CITY OF BELOIT

REPORT TO THE BELOIT LANDMARKS COMMISSION

File Number: COA-2009-10

Location: 1015 Chapin Street

Plot Plan

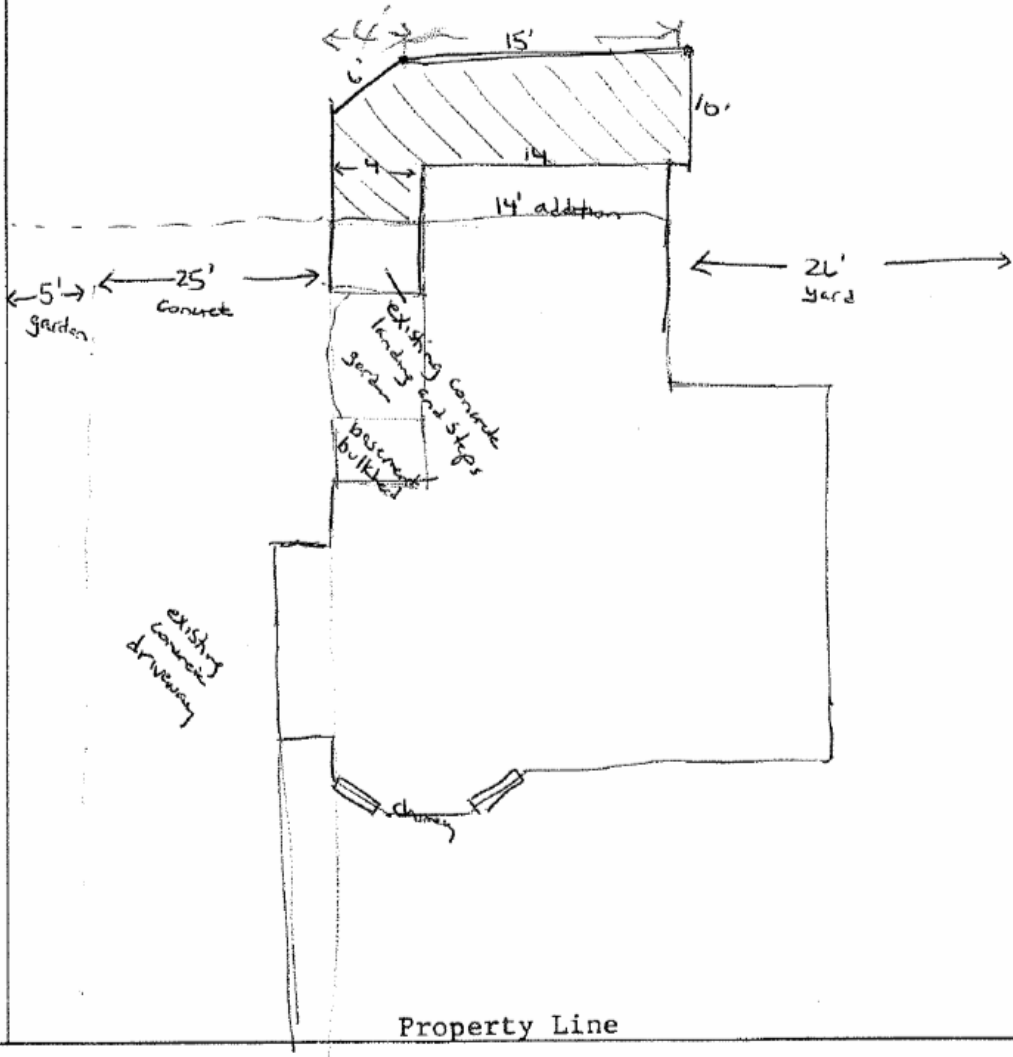
- The attached Plot Plan shows the proposed deck, which will connect to an existing concrete landing and will wrap around the northeast corner of the house.

- The proposed deck will extend approximately four feet from the side of the house, and approximately 10 feet from the rear. The proposed deck meets all applicable setbacks.

As shown on the Plot Plan, the proposed deck will be 30 feet from the western property line, 26 feet from the eastern property line, and at least 80 feet from the northern (rear) property line. The proposed setbacks greatly exceed the minimum setbacks contained in the Zoning Ordinance, and will ensure that adequate open space remains.

3. Prior to issuance of a building permit, the applicant shall submit a sketch of the proposed deck for staff review and approval. The sketch shall include the components required by condition number two.
